DEPARTMENT OF TRANSPORTATION STATE OF GEORGIA

SUBJECT APPROVED REVISED CONCEPT REPORT

**DEPARTMENT OF TRANSPORTATION
STATE OF GEORGIA
REVISED PROJECT CONCEPT REPORT**

Project Type: Safety P.I. Number: 532780
GDOT District: 5 County: Chatham
Federal Route Number: N/A State Route Number: SR204

8/9/2012 USER:cmallric	2:53:50 PM DPI07-V8 oplotborder-V81-PO-color.tbl	C:\1\Roads Data\532780\0532780\A\1\layout.dgn	STATE GA	PROJECT NUMBER	SHEET NO.	TOTAL SHEETS
---------------------------	--	---	-------------	----------------	-----------	--------------

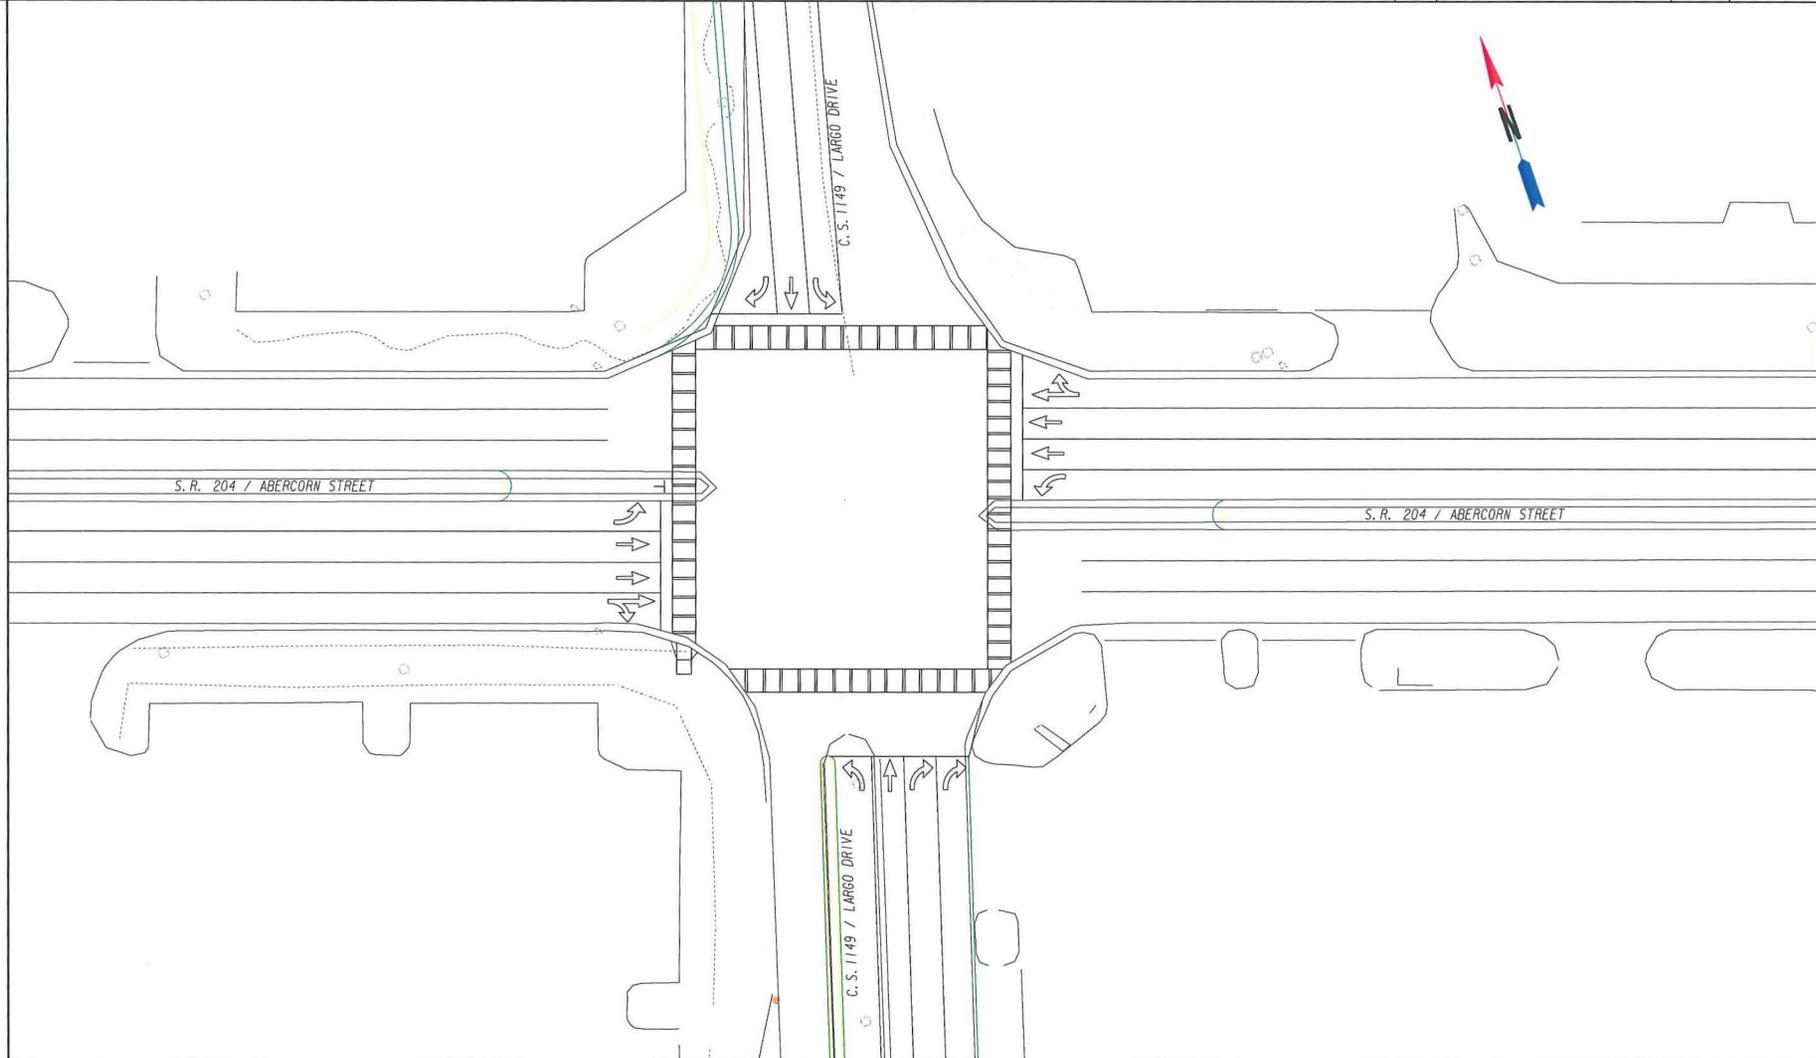
The significant changes of the approved Revised Concept Report includes: 1) removing the additional through lane and right turn lane on SR204/Abercorn Street in each direction, 2) removing the dual left turn lane on SR204/Abercorn Street westbound onto CS1149/Largo Drive, and 3) adding an additional right turn lane on CS1149/Largo Drive northbound onto SR204/Abercorn Street.

Approved Features:	Proposed Features:
<p>The 2004 approved Revised Concept Report proposed features to be revised:</p> <ul style="list-style-type: none"> • Typical Sections <ul style="list-style-type: none"> ➤ Four (4) through lanes on SR204. ➤ Separate right-turn lanes on SR204. ➤ Dual left turn lanes on westbound SR204 to southbound CS1149. ➤ 5-ft bike lane on CS1149. • Project Termini <ul style="list-style-type: none"> ➤ SR204 Mile Post 16.55 – 16.95. • Right-of-Way Limits <ul style="list-style-type: none"> ➤ 18 parcels affected. 	<p>This Revised Concept Report proposes to change the following features:</p> <ul style="list-style-type: none"> • Typical Sections <ul style="list-style-type: none"> ➤ Maintain existing three (3) through lanes on SR204. ➤ No separate right-turn lanes on SR204. ➤ Maintain the existing left turn lane and extending the storage length on westbound SR204. ➤ Maintain the existing north and southbound turning movements and extending the storage lengths on southbound CS1149. ➤ Add one (1) additional right-turn lane on northbound CS1149 to eastbound SR204. ➤ Maintain existing 4-ft bike lanes on CS1149. • Project Termini <ul style="list-style-type: none"> ➤ SR204 Mile Post 16.58 – 16.84 • Right of Way <ul style="list-style-type: none"> ➤ No parcels affected

<p>Reason(s) for change: The proposed changes are in response to the attached Traffic Engineering Study conducted by District 5 Traffic Operations and the traffic analysis conducted by the Office of Roadway Design which is summarized in the attached Intersection Alternative Matrix. Both studies indicate the proposed improvements in the 2004 Revised Concept Report will not improve the intersection delay, particularly along the mainline, SR204/Abercorn Street. Major improvements such as the addition of through lanes are necessary from Rio Road to Truman Parkway to improve the LOS of this intersection. Project PI# 0002922 proposes to widen SR204/Abercorn Street from 6 to 8-lanes but is in long-range. The Chatham County MPO is currently studying the SR204 corridor for different alternatives to project PI# 0002922.</p>

STATE OF GEORGIA
DEPARTMENT OF TRANSPORTATION
OFFICE: ROADWAY DESIGN
TYPICAL SECTIONS
SR 204 / ABERCORN ST
@ LARGO DRIVE

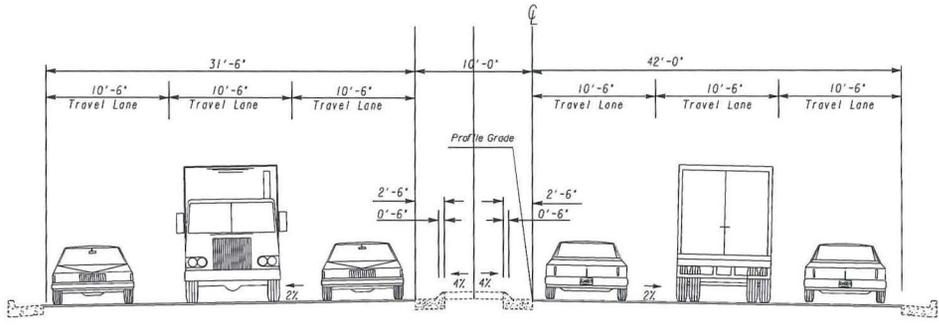
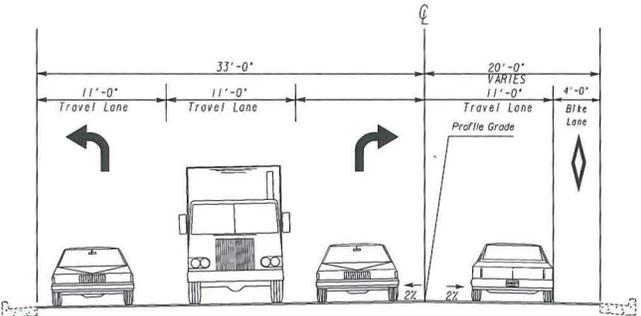
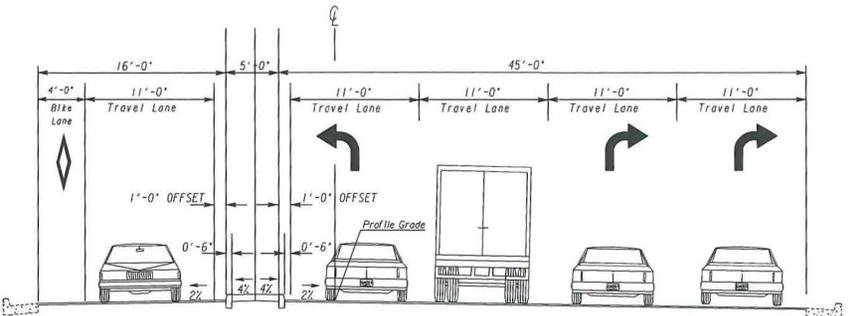
Although the Justification Statement states that SR204/Abercorn Street and CS1149/Largo Drive are not on designated State Bicycle Routes, the Office of Roadway Design proposes to maintain the current 4-ft bike lane on CS1149/Largo Drive (see attached Typical Section).
